An Board Pleanála Oral Hearing

[MetroLink – Estuary to Charlemont via Dublin Airport] ABP – 314724-22

Bernard Seymour

Location 8 Re-assessment of Station, entirely within St Stephen's Green East Carriageway

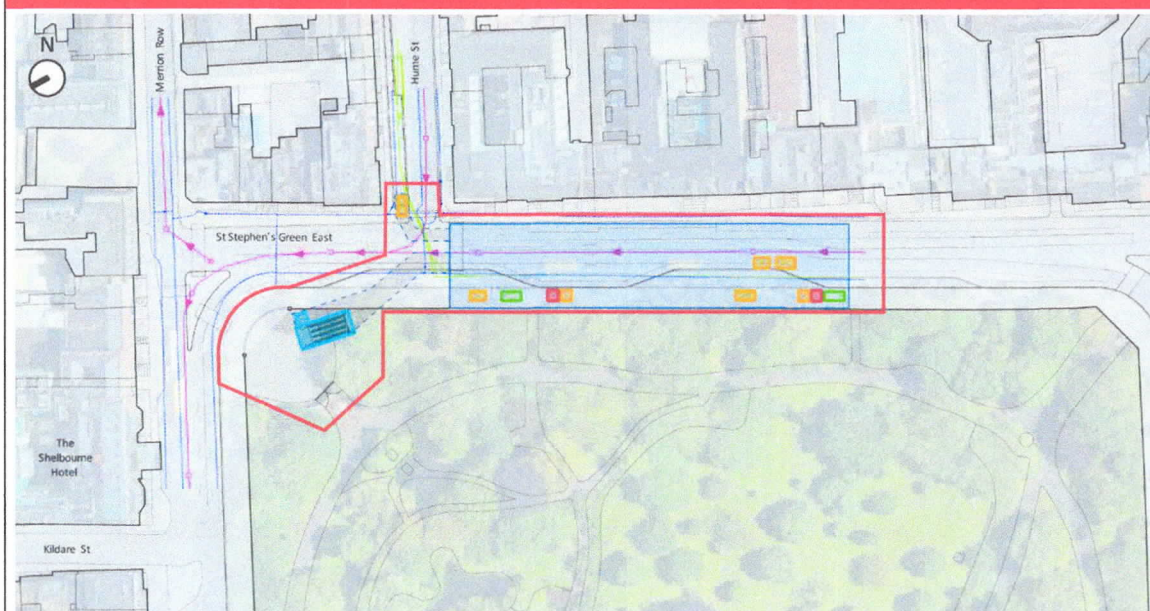
1. The mined or tunnelled options have been dismissed without adequate recognition of context.
2. The extended project timeline (unproven) in the St. Stephen's Green east roadway location should be viewed beyond the Metrolink delivery. It is a civic venture to be done right.
3. The solution that preserves the setting of St. Stephen's Green is expensive.
4. The damage to St Stephen's Green is an inestimable cost and permanent.
5. The best outcome is one where during the metro's life all traces of its construction will be invisible to St. Stephen's Green.
